TISDALE WEIR REHABILITATION AND FISH PASSAGE PROJECT

Final Environmental Impact Report

Prepared for
California Department of Water Resources

August 2021

Figure 23
TUFLOW Model – Change in Average Depth by Parcel (Dry Days)
Tisdale and Sutter Bypass (Critical WY's), Project Conditions

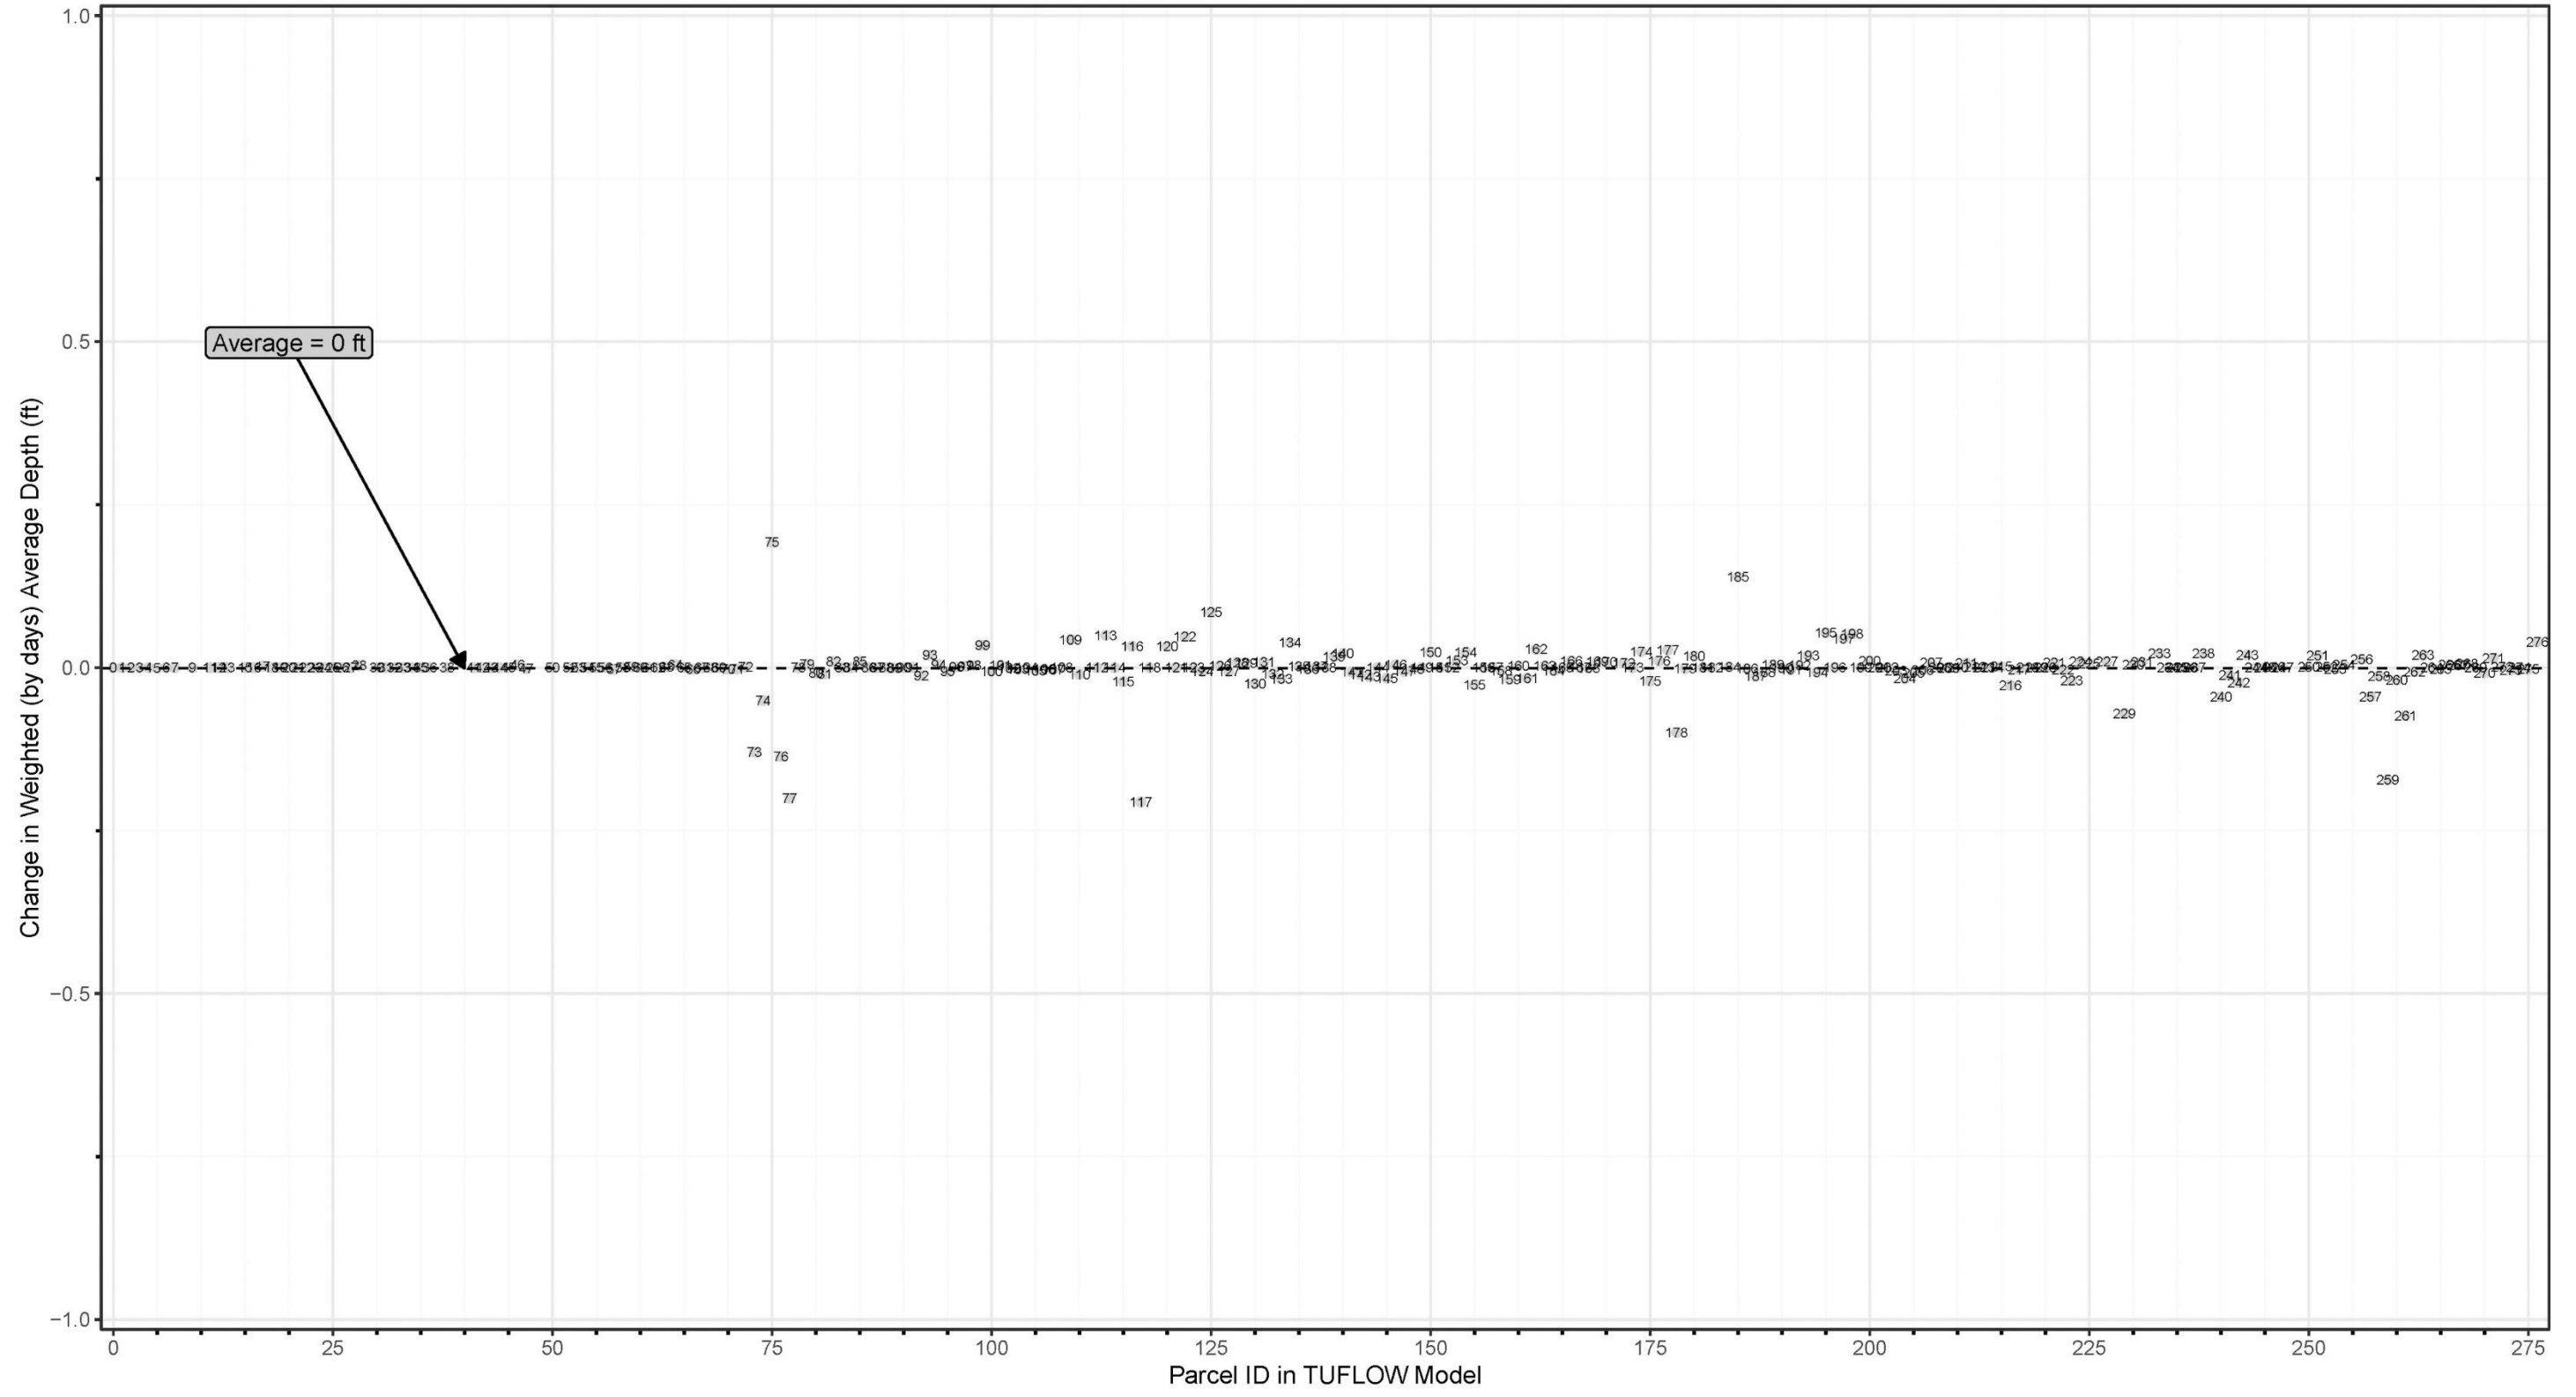
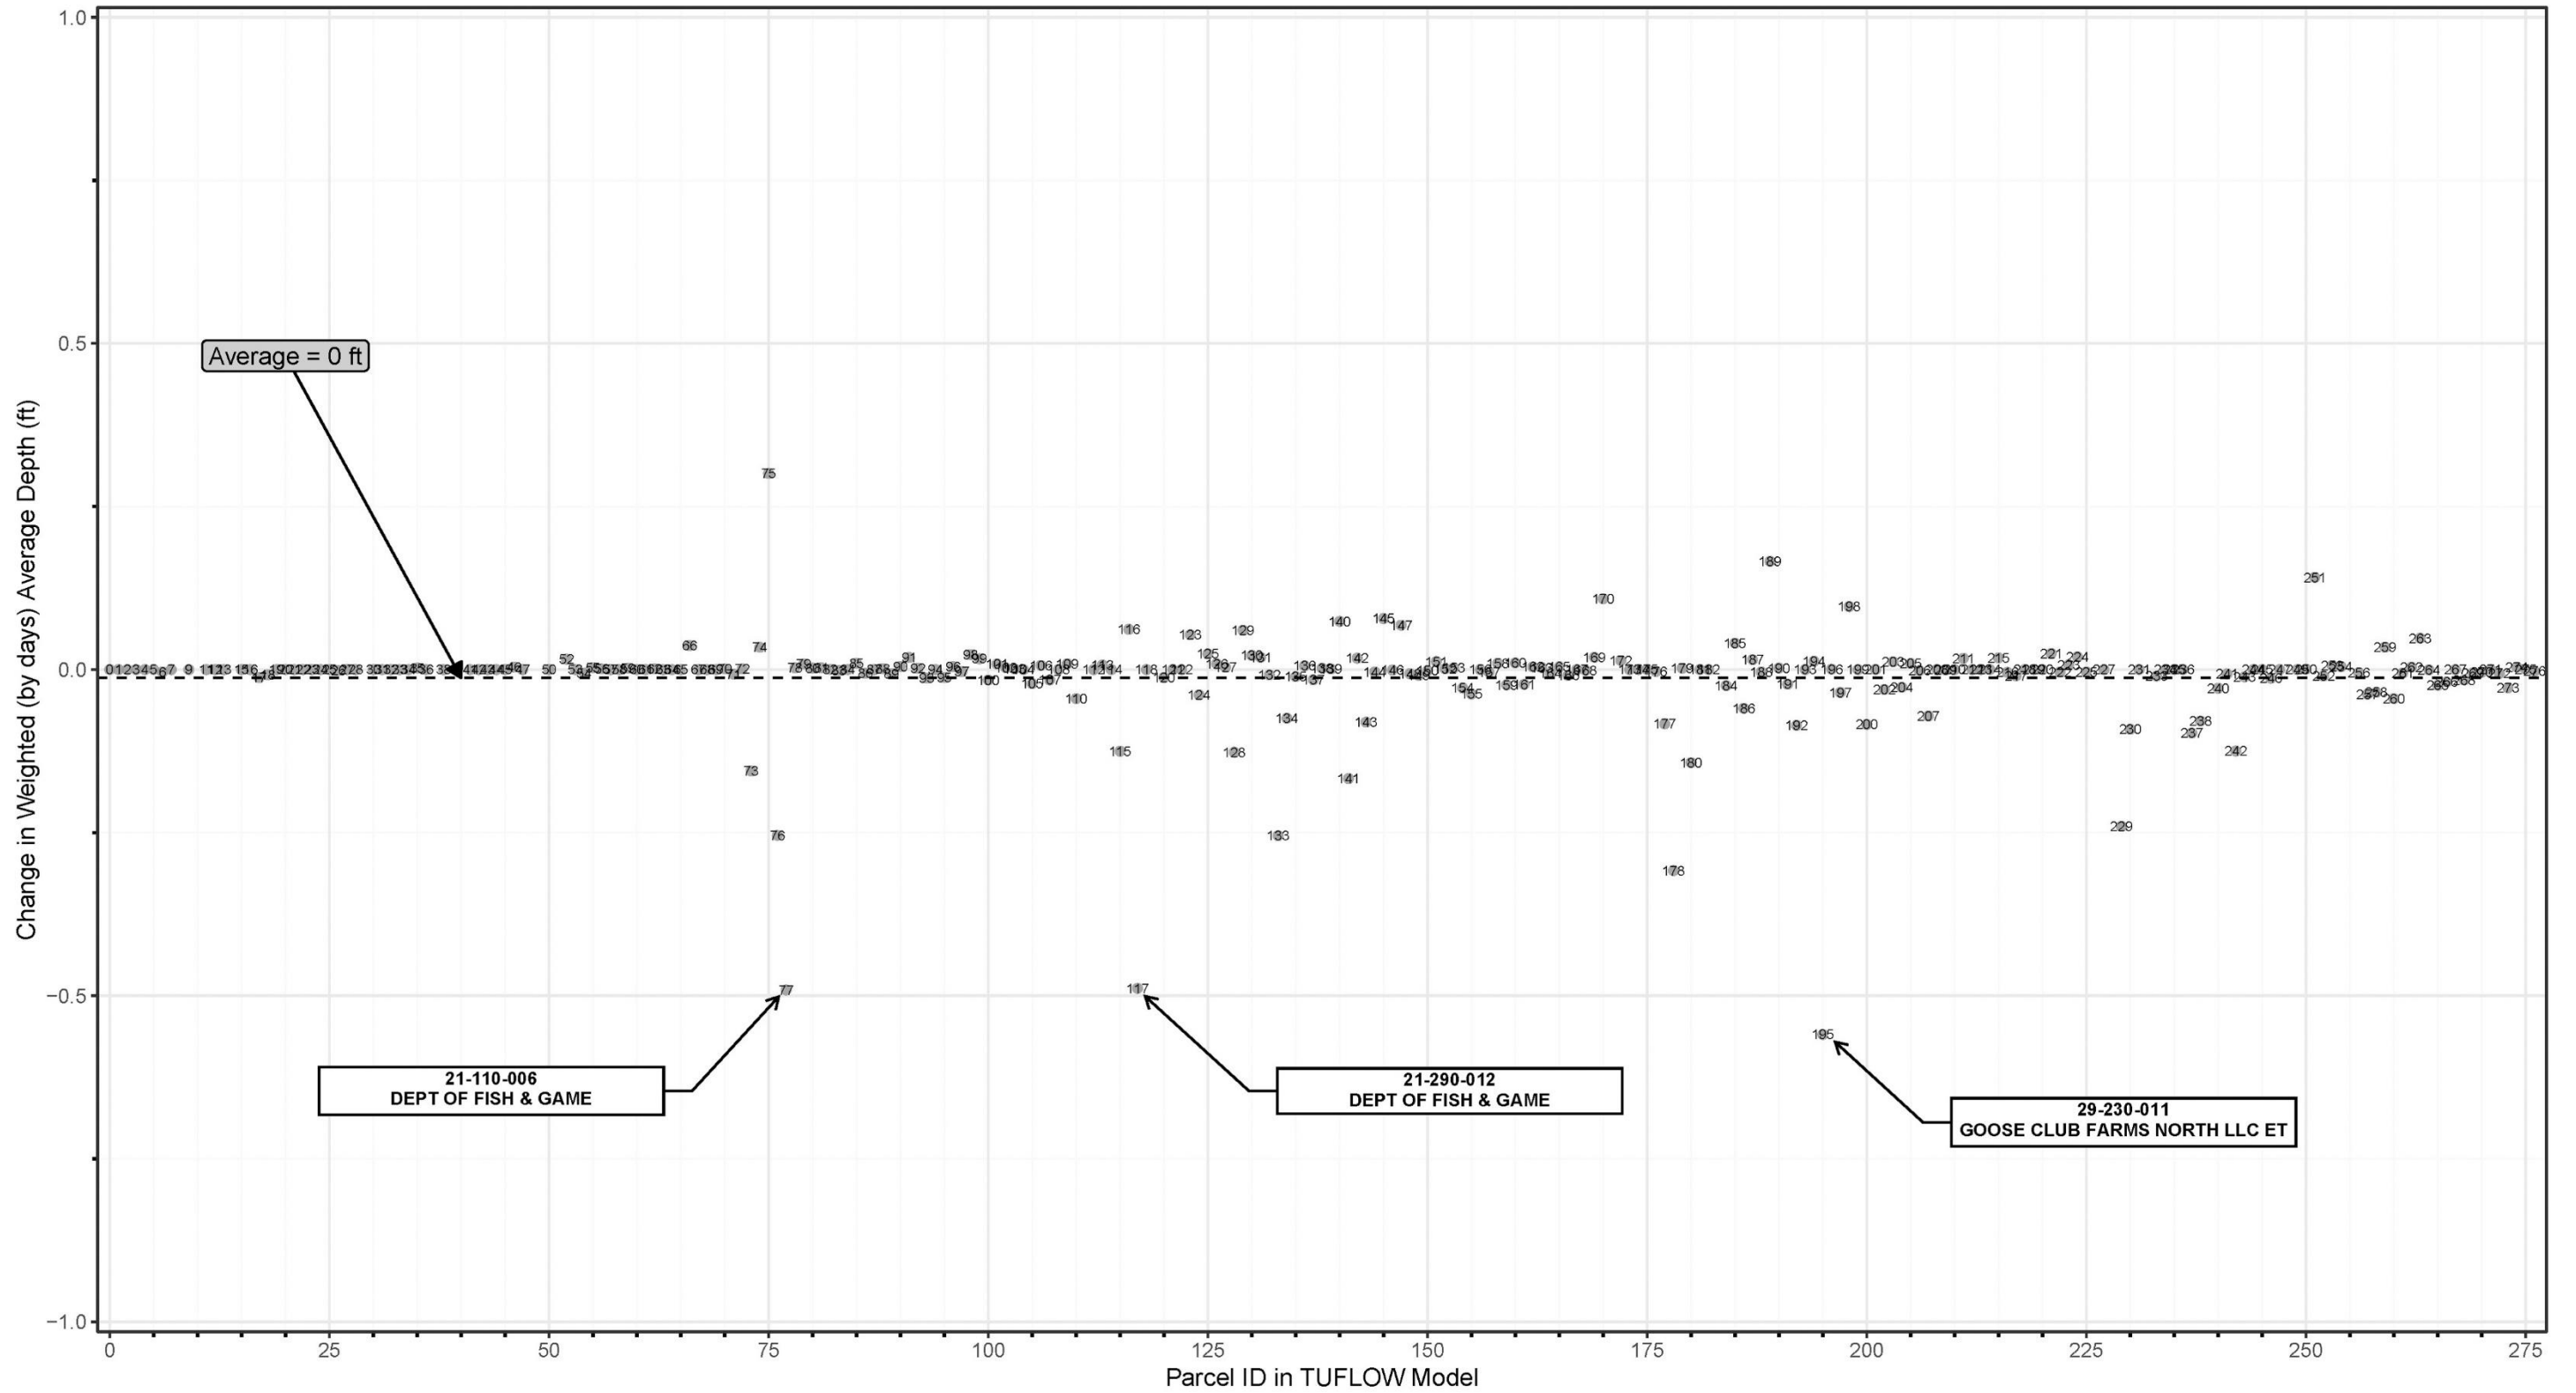
Figures 13 through 24 in Attachment E of this FEIR present the average changes in water depth, by water year type, for each parcel in the Sutter Bypass and, as shown, the predicted changes in water depth are very minor. As evident in Figures 13 through 24, the predicted increases in depth for wet days and dry days that are greater than approximately 0.5 feet are for parcels that belong to the Sacramento/San Joaquin Drainage District or the California Department of Fish and Wildlife (CDFW). In addition, Attachment F of this FEIR provides the change in the number of wet days for the waterfowl season for all water years and parcels in the Sutter Bypass.
